Interactive comment on “TerrSysMP-PDAF (version 1.0): a modular high-performance data assimilation framework for an integrated land surface–subsurface model” by W. Kurtz et al.

General comments

Fig. 1. Absolute average error of soil water content for open-loop (left) and assimilation (right) at a depth of -65 cm from April–June 2013.

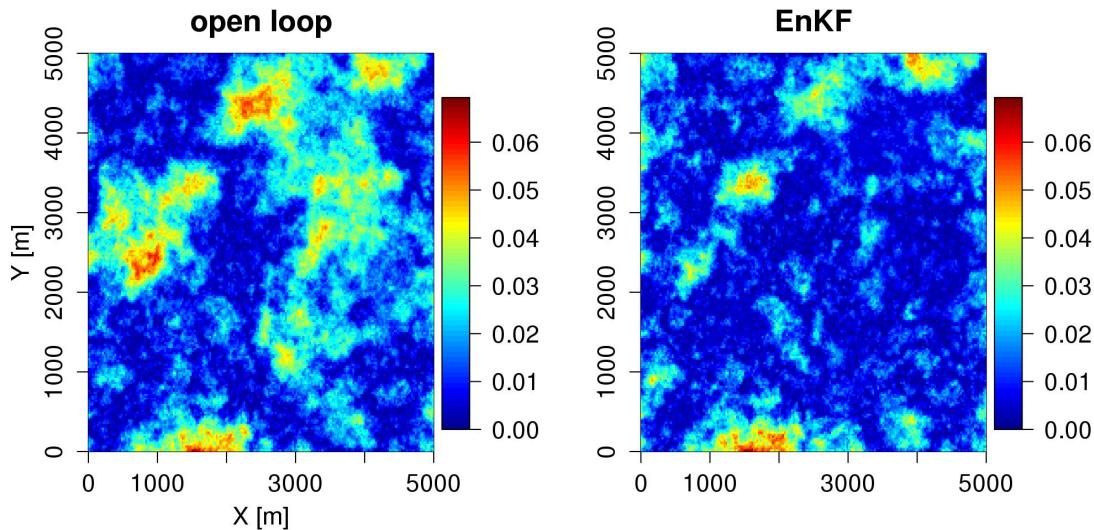
14. Figure 10 There is a phantom line at $y = 1500 \text{ m}$. Not sure if this is a pdf rendering problem.

Reply: Unfortunately, we found that there was a problem in the calculation of the AAE fields (time shift between the reference and the ensemble mean of soil moisture). Based on the new calculations, the discontinuity at $y=1500\text{m}$ vanished and the background AAE value of 0.03 was decreased to zero (see Fig. 1 below). Other results were not affected by this calculation error.
